# Independent Review of Hydraulic Modeling for Aliso Canyon Risk Assessment

**Walker & Associates, Los Alamos National Laboratory  
Joint Agency Workshop on Aliso Canyon Action Plan for  
Local Energy Reliability for Winter of 2016 to 2017**

**August 26, 2016**

# Summer assessment – risk analysis

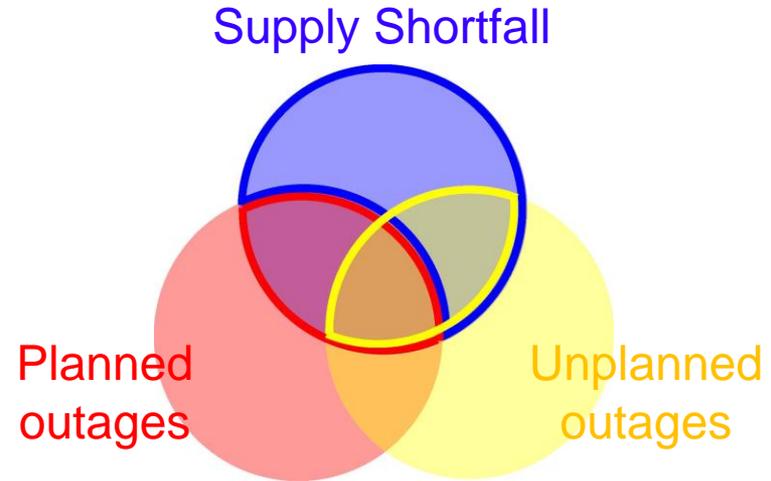
## Review Team view on risk analysis:

- Appears to overestimate the **likelihood of low impact events** (e.g. days with 150mmcfcd curtailment)
- Appears to underestimate **impact of low likelihood events** (i.e. planned & unplanned outage on high load day)

- Mitigation measures key to avoiding expected curtailments
- Mitigation was not accounted for in the initial risk assessment

Figure 10: 4.7 Bcf, No Additional Outages – Northern System and Los Angeles Basin Pressures

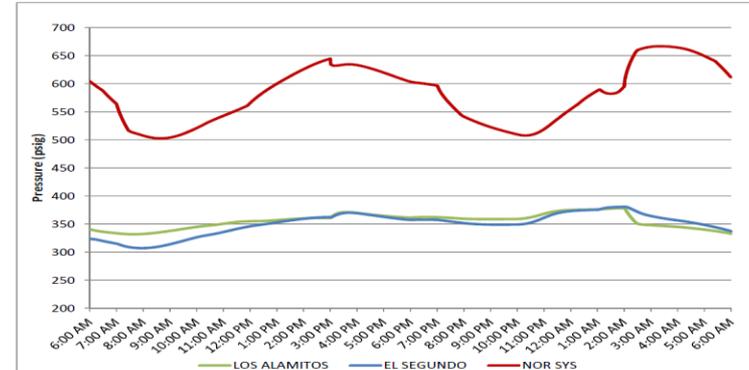
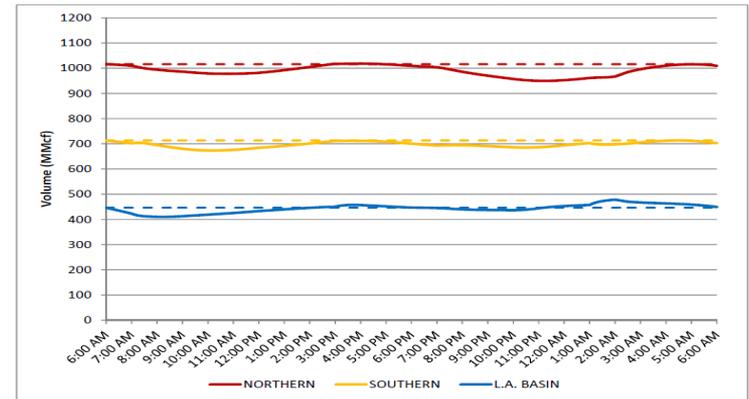
- Maximum delivery with usual distribution of consumptions, everything in service
- 4.7 BCF found to be the estimate of maximum system utilization, given all operational factors, and capabilities of commercially available software
- Pipeline vs. storage tradeoff (Honor Rancho)

## Justification:

- System pressures are maintained
- Subsystem linepacks are recovered
- Based on operating protocols of SoCalGas gas control department
